REMARKS

Claims 1, 3-19, and 21-27 are pending. Claims 2 and 20 have been canceled. Claims 12-15 have been withdrawn from consideration. Claims 23-27 have been added by the present amendment.

FIG. 3

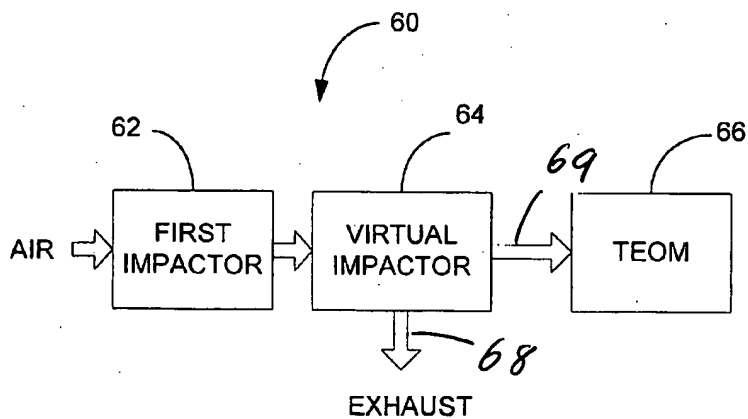
The specification and the drawings have been amended. The specification has been amended to accord with FIG. 3. FIG. 3 has been amended to add reference numerals 68, 69 to indicate the major flow and minor flow out of virtual impactor 64 as described in paragraph 0022. FIG. 4 has been amended to correct the text in block 70 to accord with paragraph 0023. No new matter has been added.
